IMPORTANT PRODUCT INFORMATION

Product: **IC693DSM302 Module (“DSM302”)**
 IC693DSM302AD
 Firmware Version 1.30

Purpose of this Document

Enhanced Follower Axis Ramp Control

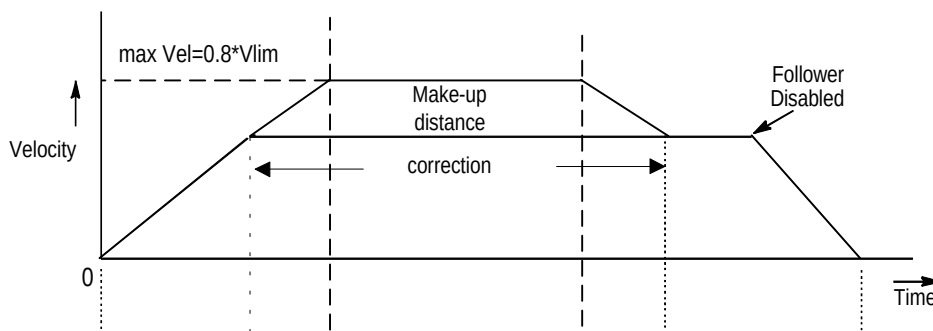
The Follower Axis Ramp Control Function is enhanced in DSM firmware release 1.30. The enhancement improves motion smoothness. Prior to this release, when the follower was active and the master in motion, the acceleration/deceleration control during the make-up correction phase was not controlled by a velocity profile. This could cause unwanted machine shock. The enhanced method uses a trapezoidal velocity profile to address this problem. During the entire make-up correction phase, the acceleration/deceleration is limited to the jog acceleration value. Also during the correction, the velocity is not allowed to exceed the maximum. Appropriate warning/error codes notify the user about abnormal operation (see error table below).

The figure below shows the velocity profile during the follower ramp cycle. *Note: The enhanced follower make-up may affect existing applications that use the old follower make-up feature.*
